# D/DRC Case

1907 Henderson Street

**DESIGN/DEVELOPMENT REVIEW COMMISSION**  
**DESIGN REVIEW DISTRICT**  
**HISTORIC AGENDA**  
**EVALUATION SHEET**  
**Case # 5**

**NATURE OF REQUEST:** Request Certificate of Design Approval for exterior changes and preliminary approval for the Bailey Bill

⑥ Hoy board plans

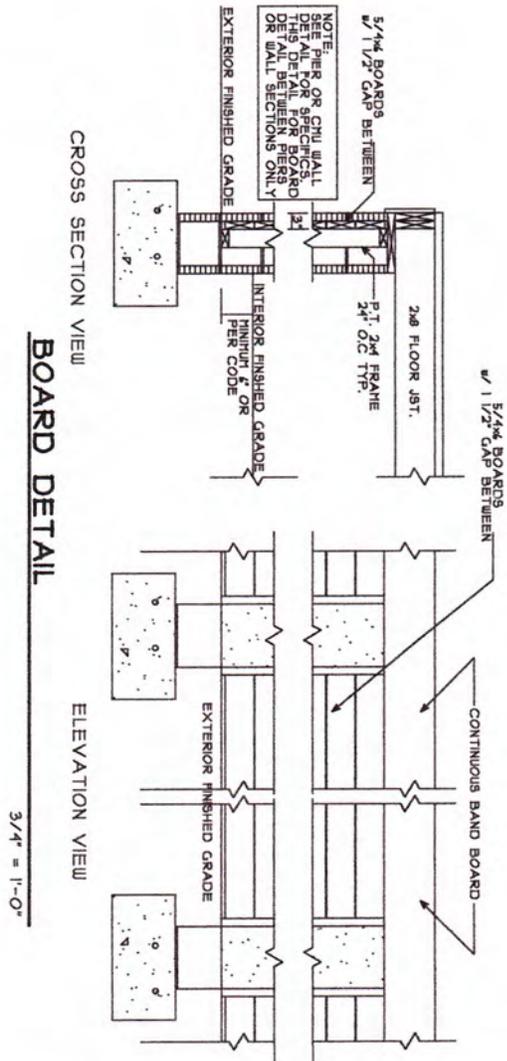
The applicant is proposing a horizontal “hog board” between the brick piers in the foundation. An architectural rendering provided by the applicant shows this to be made up of 5/4”x 6” boards, which is the size of a deck board. This is not a typical or historic treatment for this house or for historic houses in the area and would therefore create a false sense of historical development and be considered “conjectural.” The photograph provided by the applicant shows this board looking like large louvers and creating an appearance that is unlike anything that would have been found on this building historically.

As described above, the change proposed to the foundation, the addition of “hog board,” is not appropriate for the building. The example provided by the applicant appears to be a new house, and the use of this feature would create a false sense of historical development by introducing a modern feature.

Staff finds that the proposal for the “hog board” between the brick pier foundation does not meet either Sections 17-674(d) for the Landmark District or Section 17-698 of the City Ordinance for the Bailey Bill and recommends denial of that part of the proposal. However, the remainder of the

If the applicant desired to use a material that was typical of this area and that was used historically, such as brick, concrete block, lattice or vertical wood pickets, then it would keep the building more in line with what would have been available for this building. For

ventilation under the house vents may need to be installed if a solid material is installed rather than a lattice, which is a detail that could be worked out with staff.

proposal is in keeping with those sections of the ordinance and staff recommends a Certificate of Design Approval and a recommendation for preliminary certification for the Bailey Bill if that item is removed or replaced with an item more in keeping with the ordinance. In that instance, all approvals and details may be deferred to staff.
